LOT 5, FALCON MARKETPLACE

GRADING & EROSION CONTROL DOCUMENTS

EPC STORMWATER REVIEW COMMENTS ARE SHOWN IN ORANGE BOXES WITH BLACK TEXT

INITIAL GRADING & EROSION CONTROL PLAN

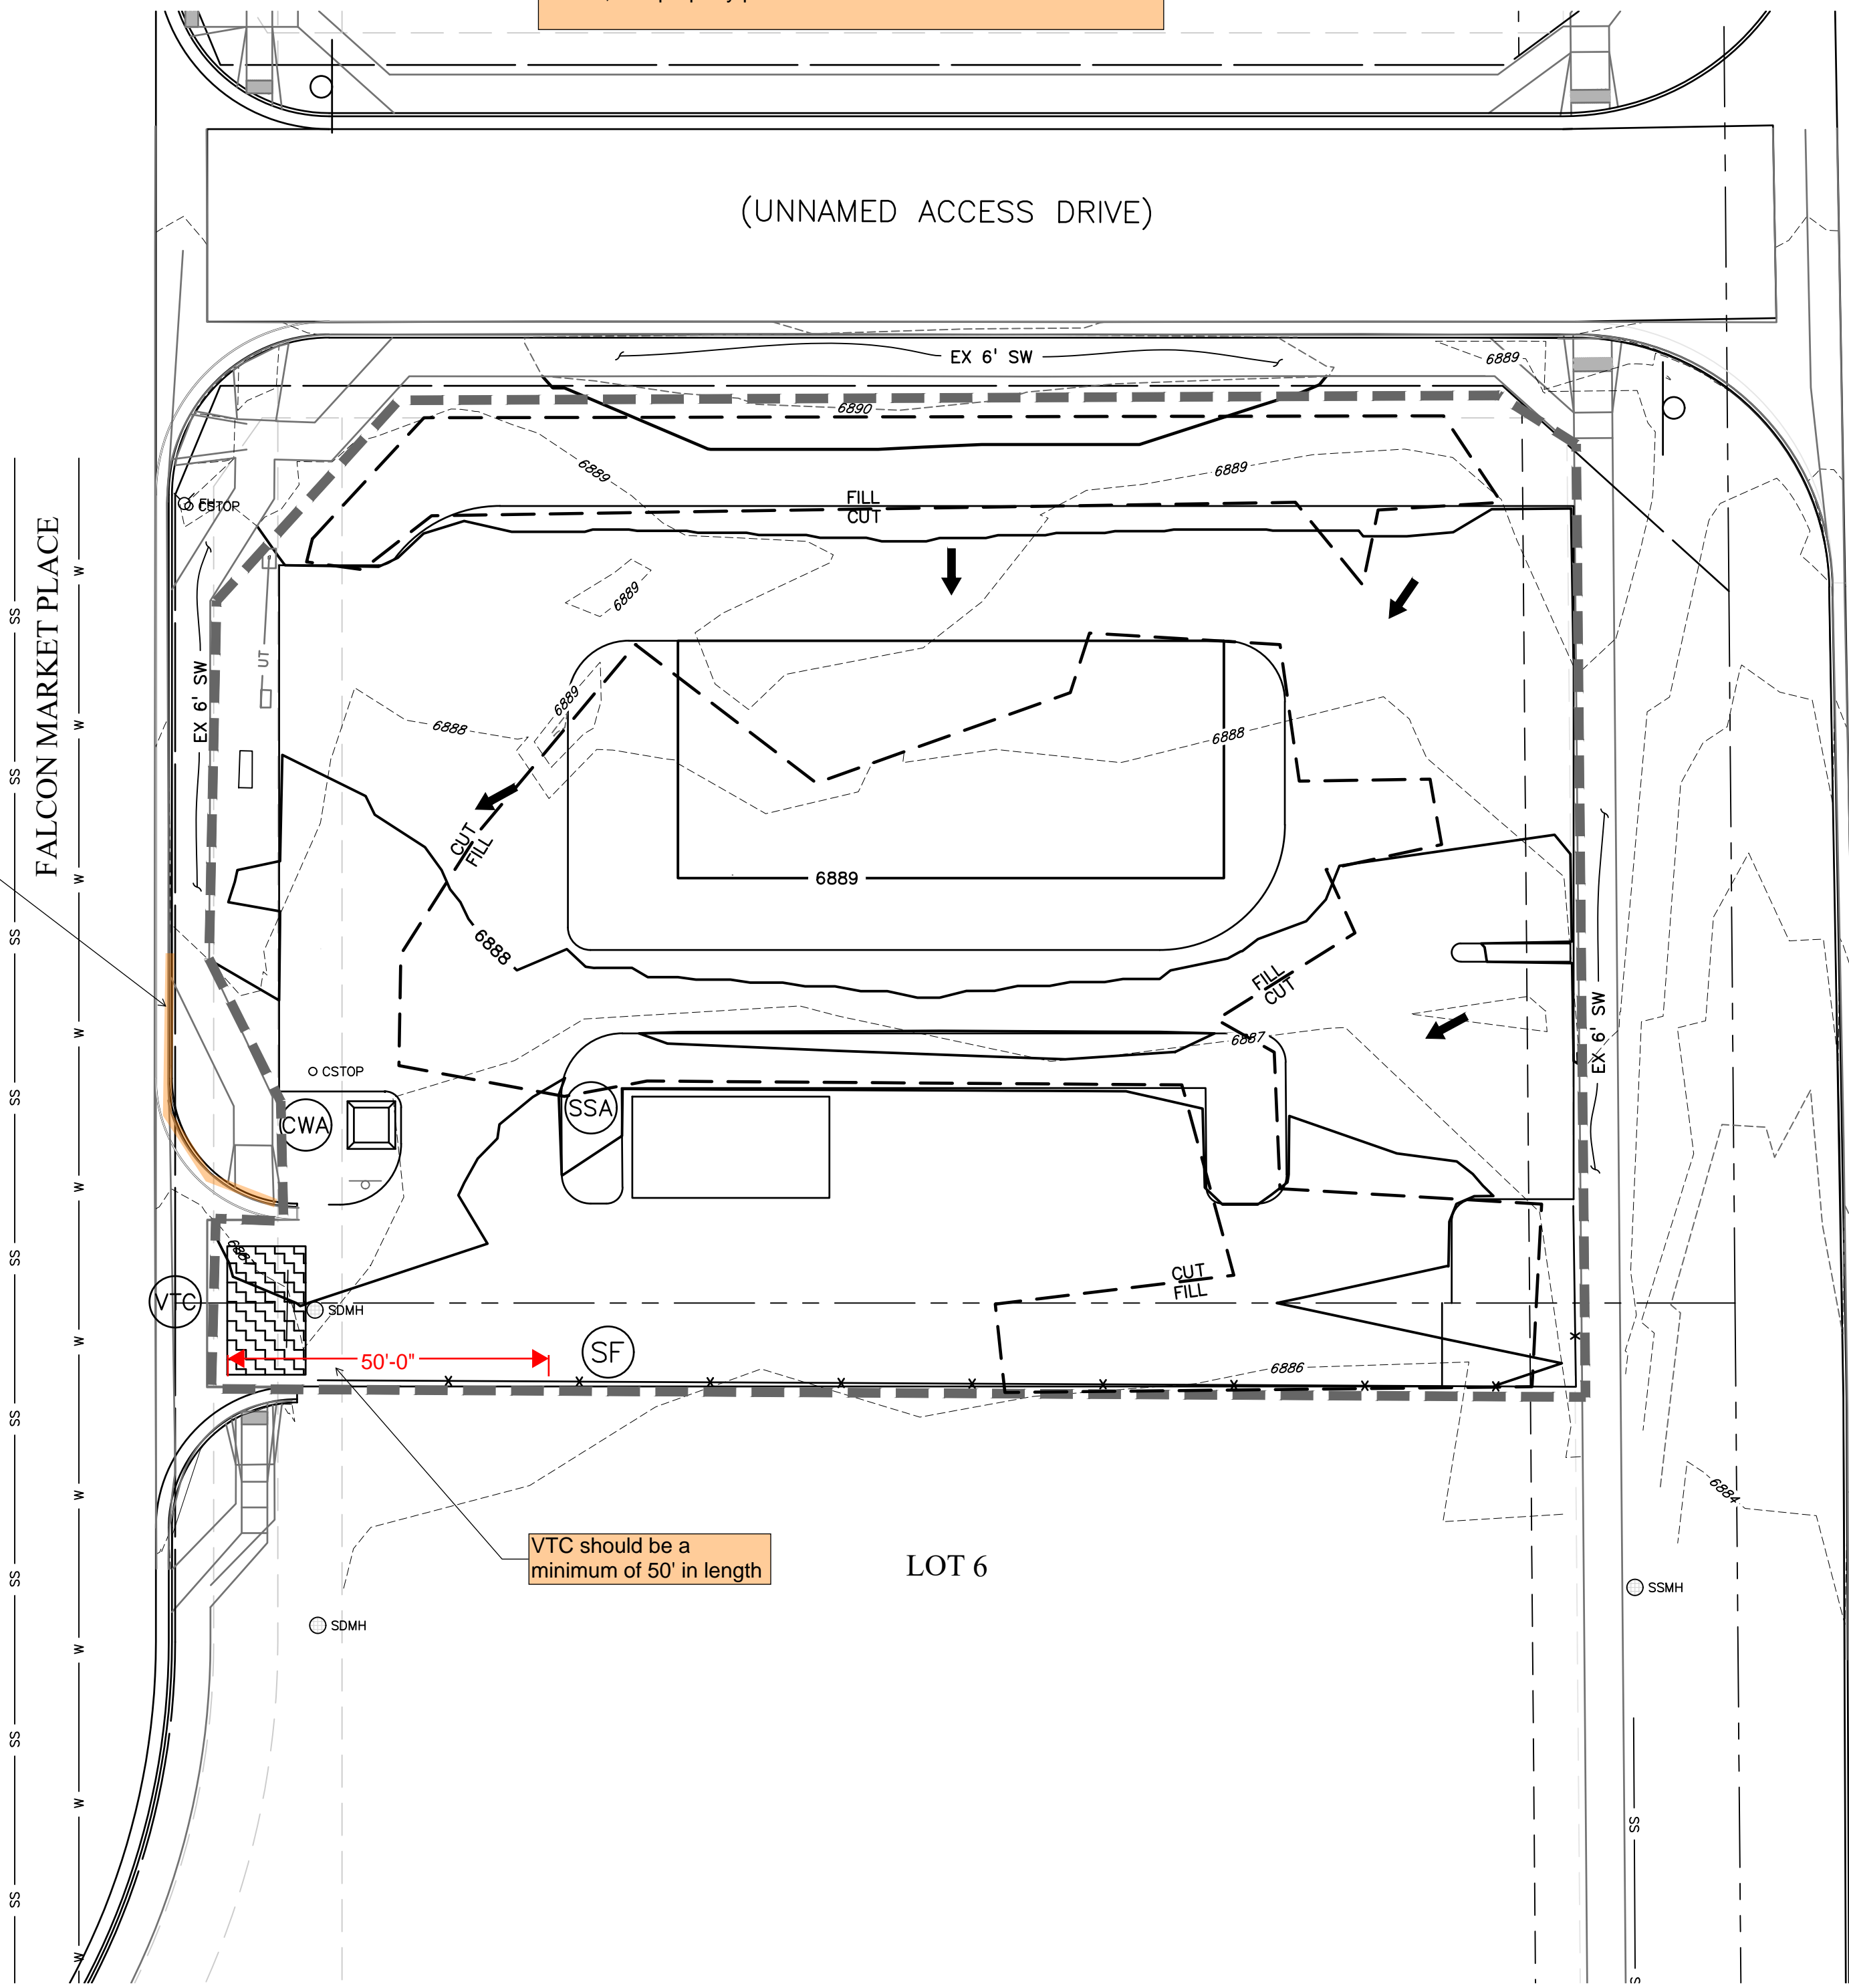
Use inset to show location of existing pond.

Label adjacent city/town/jurisdictional boundaries, subdivision names, and property parcel numbers

add silt fence

VTC should be a minimum of 50' in length

add a note about existing vegetation at the site.

in order to comply with the swmp requirements please add the following notes:
 - No batch plants will be utilized onsite.
 - The site is not within 50' of any surface waters

INTERIM/FINAL GRADING & EROSION CONTROL PLAN

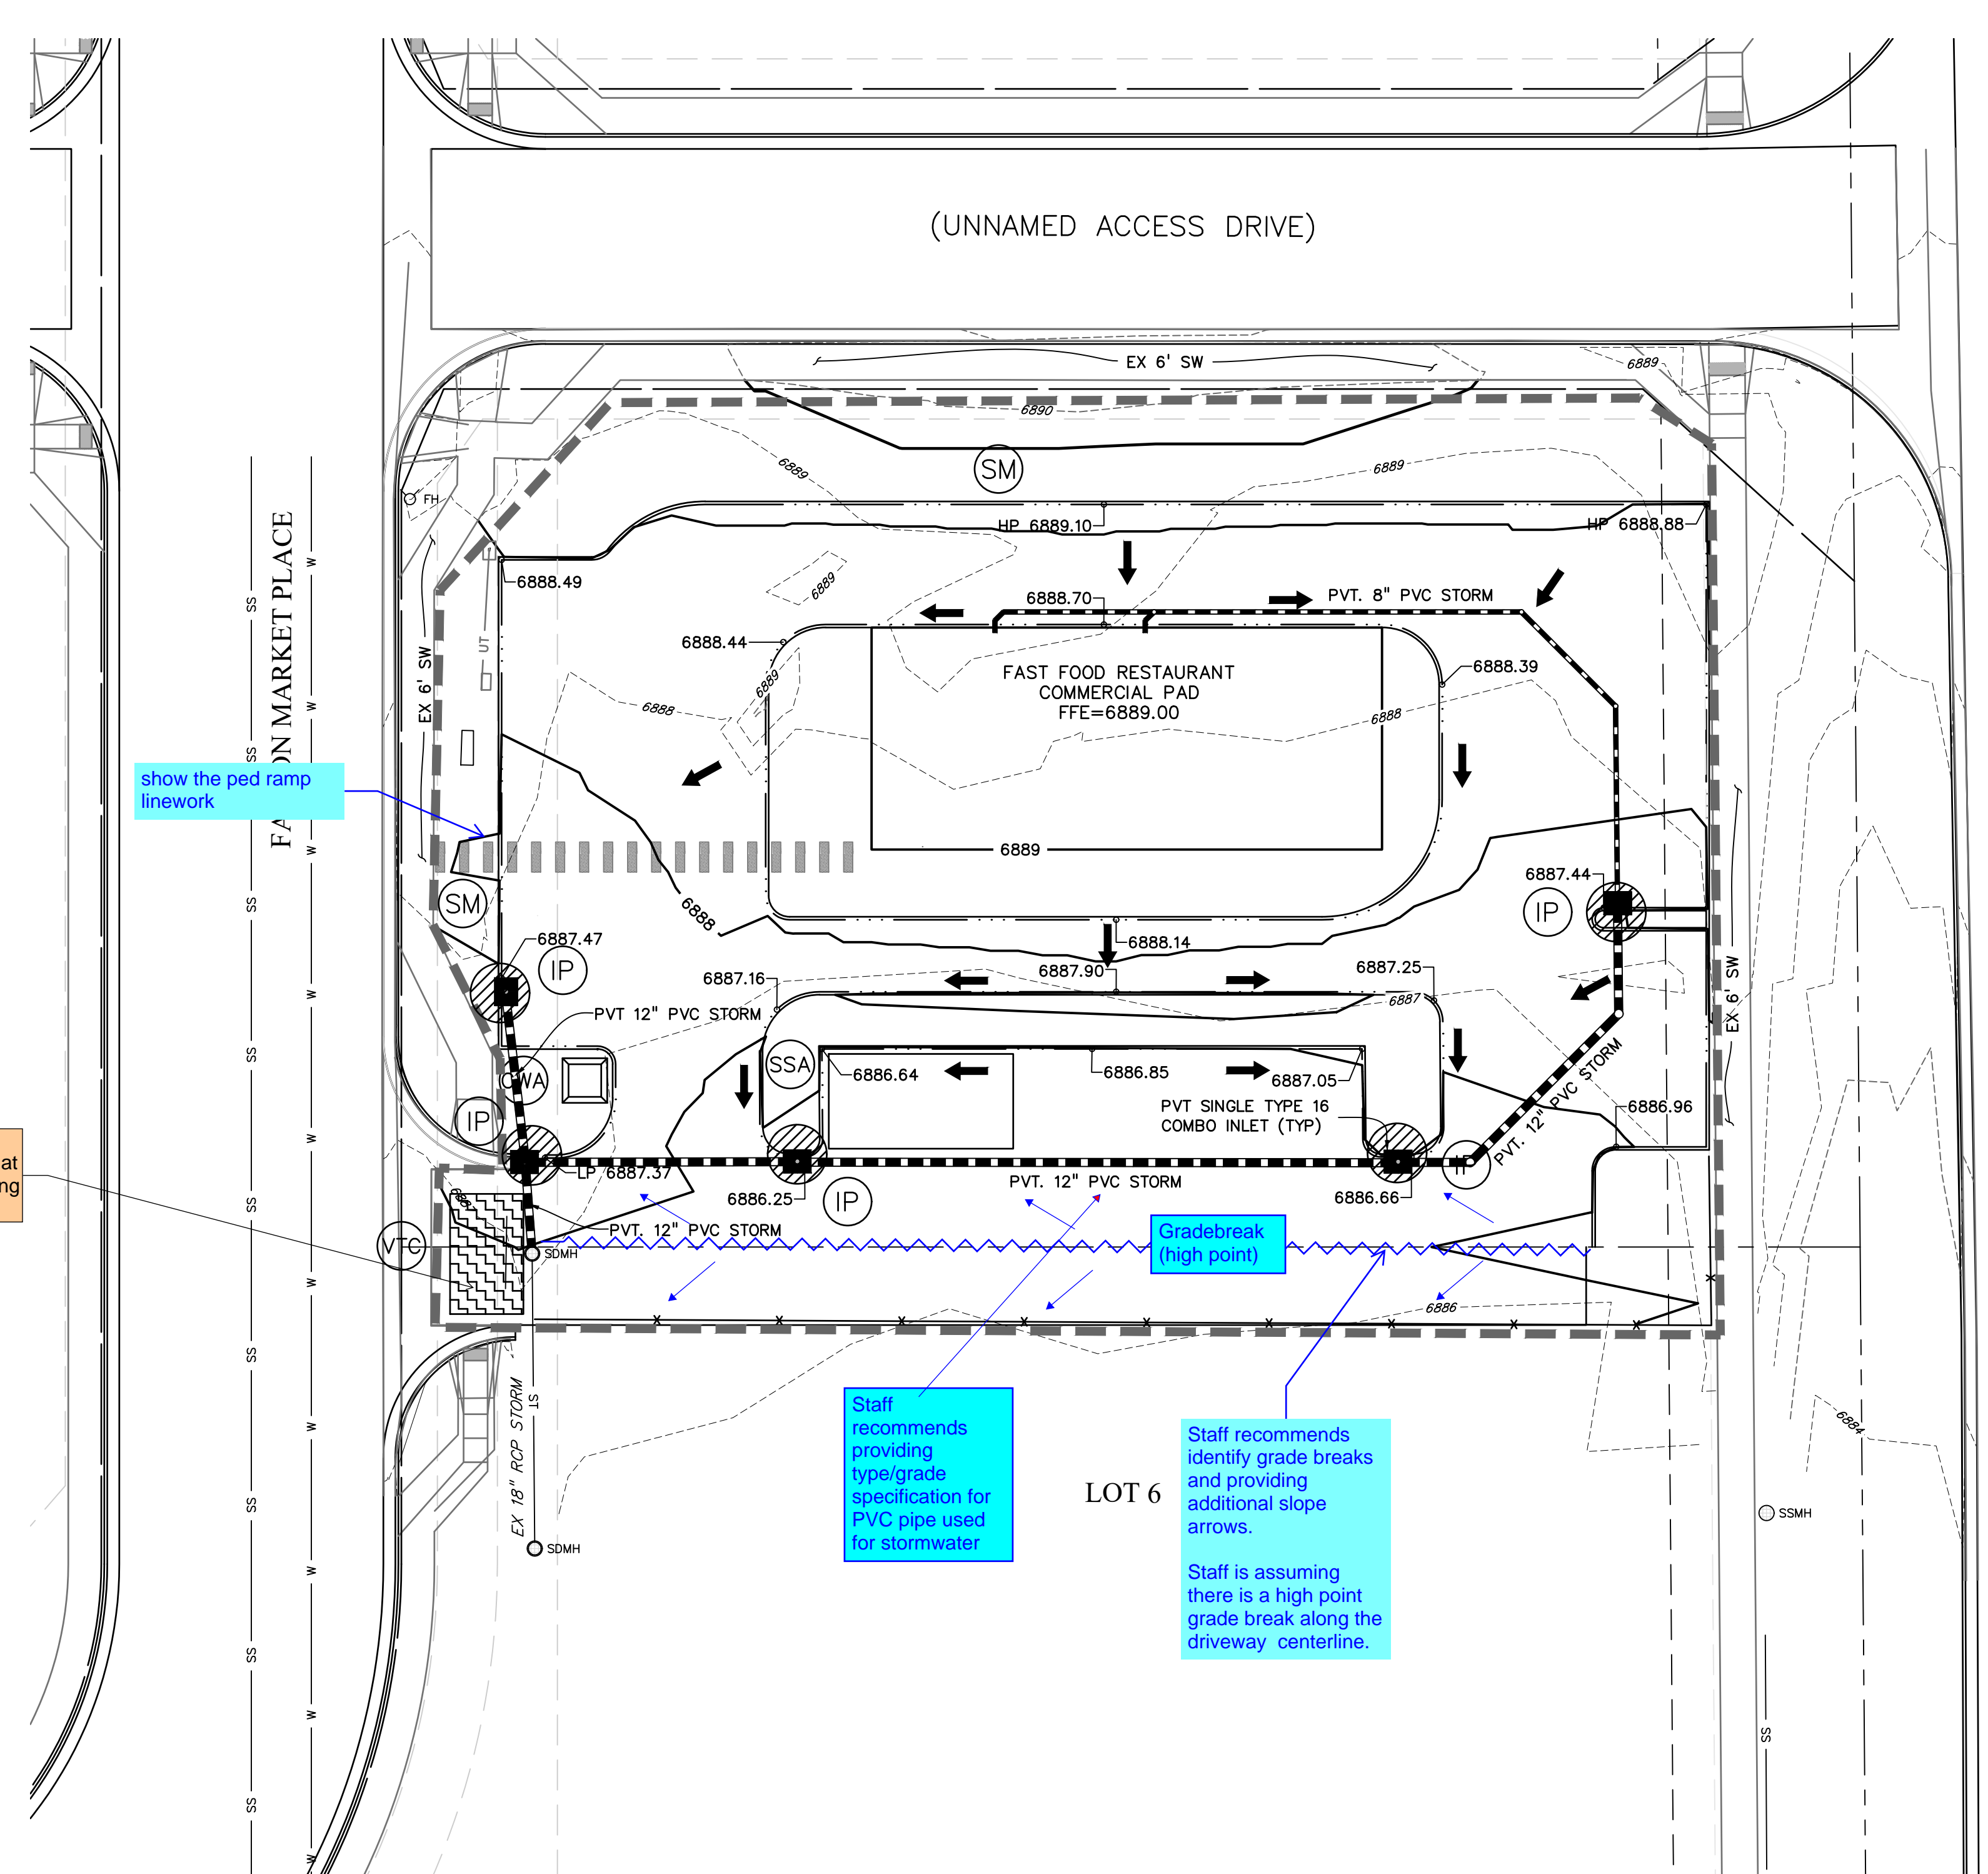
is there another access location so that you can avoid covering MH with VTC?

show the ped ramp linework

Staff recommends providing type/grade specification for PVC pipe used for stormwater

Staff recommends identify grade breaks and providing additional slope arrows.
Staff is assuming there is a high point grade break along the driveway centerline.

show all easements
